**Water Right Conditions
Tracking Slip**

FILE ## G-17407

PUBLIC INTEREST REVIEW FOR GROUND WATER APPLICATIONS

SUBJECT: Application G- 17407 Supersedes review of _____
Date of Review(s) _____

Application G-17407, Edna Read

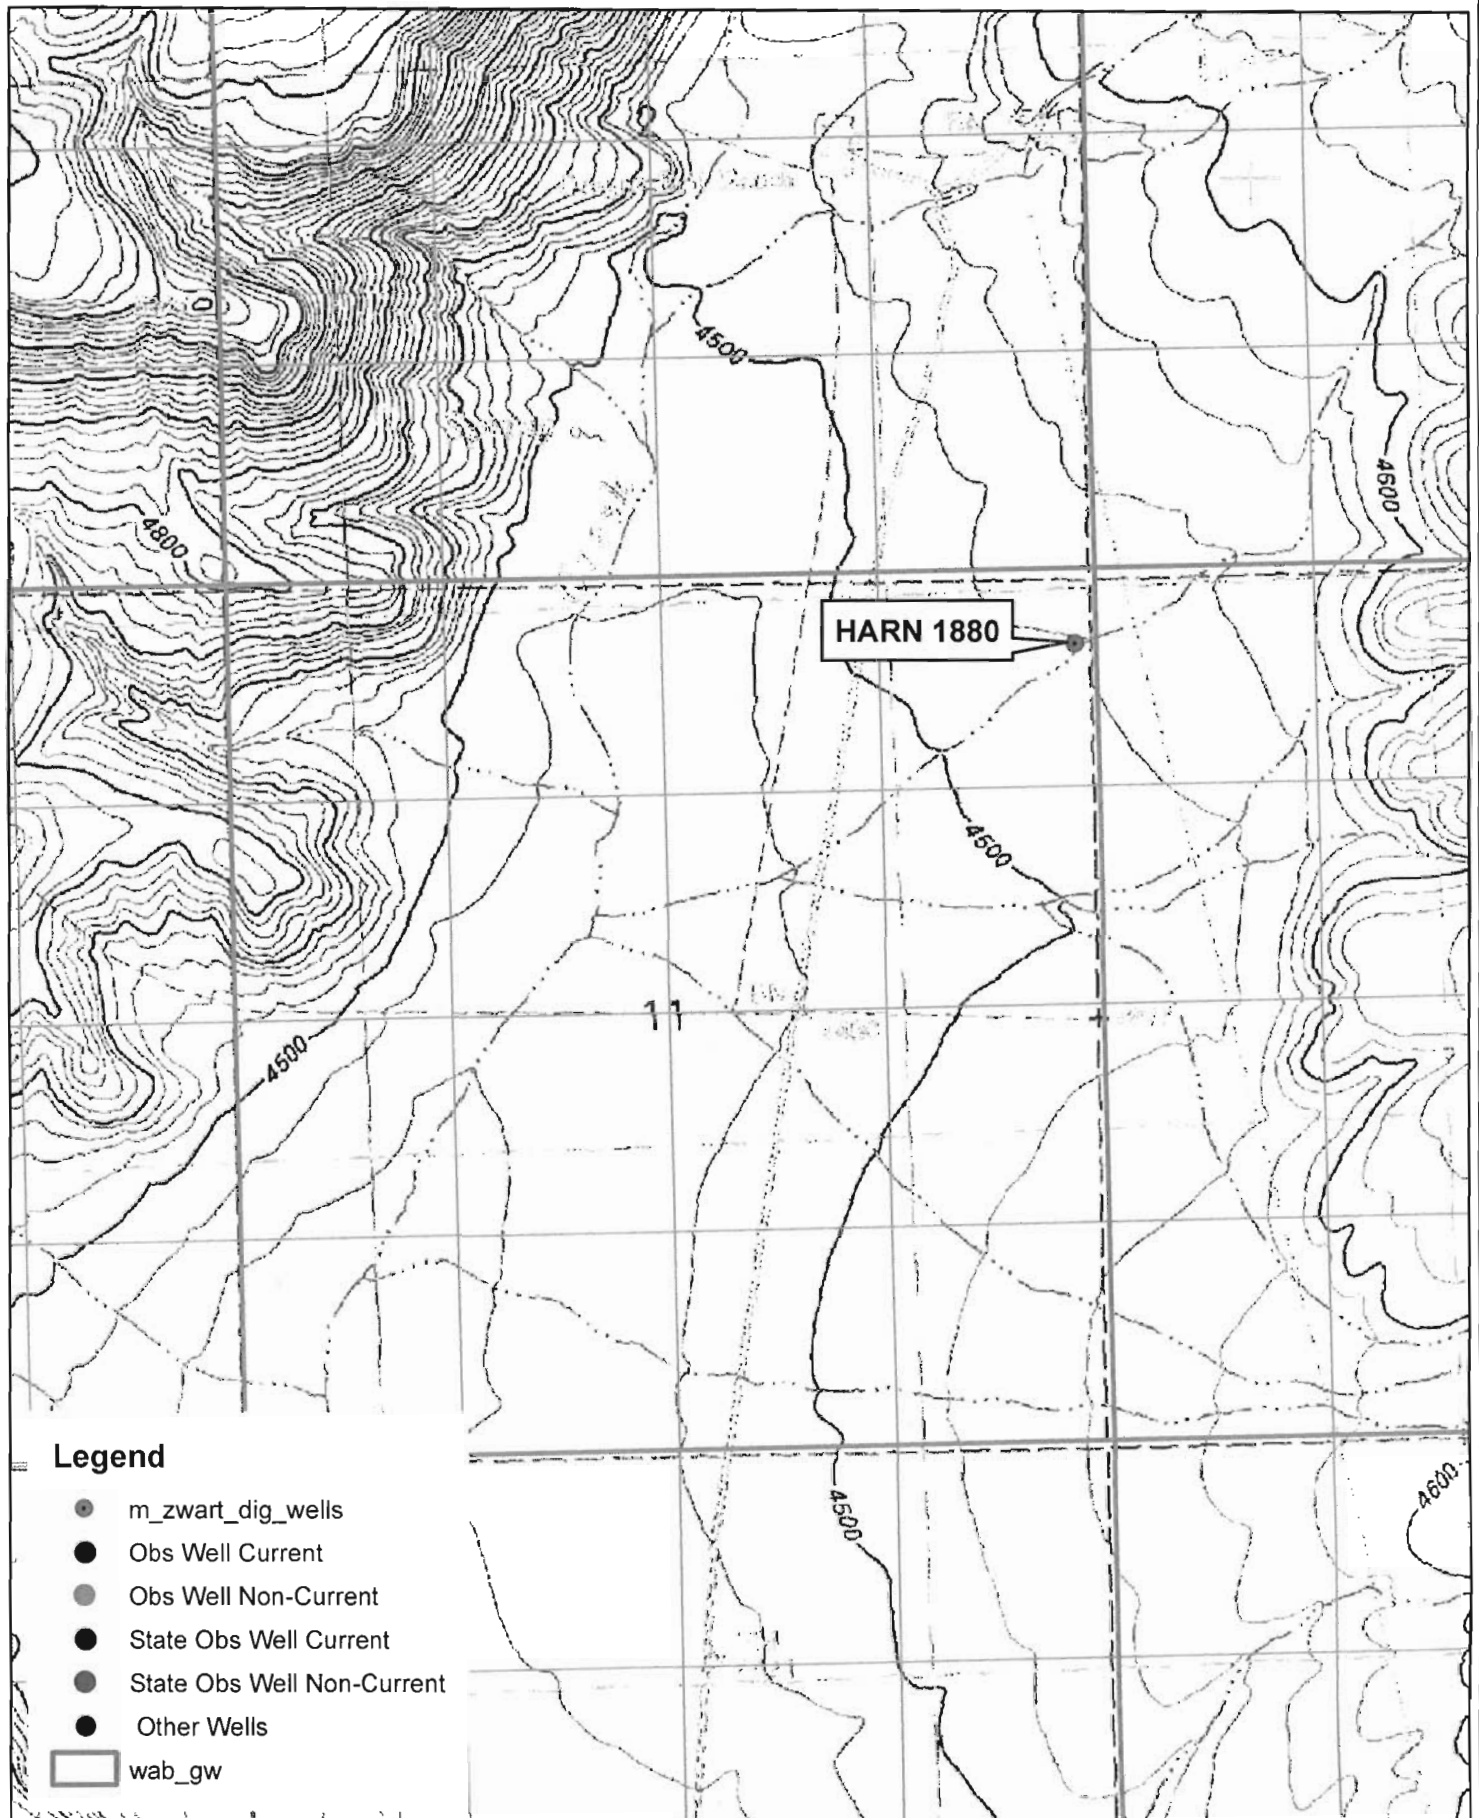
- B3. Ground water availability remarks: This area is remote and there is very limited development of groundwater in the vicinity. There are also no nearby observation wells.

Basis for aquifer confinement evaluation: The well log does not report the depth to the first water-bearing zone. Other nearby well logs suggest the aquifer is semi-confined.

Basis for aquifer hydraulic connection evaluation: The head relationship suggests that the aquifer is not hydraulically connected with the nearest creek reaches, but the heads also indicate that the aquifer is likely discharging to the downstream reaches of Rincon Creek within and beyond one mile of the well.

Basis for impact evaluation: This section applies, but the lack of WAB data for Rincon Creek precludes meaningful calculation of potential interference.
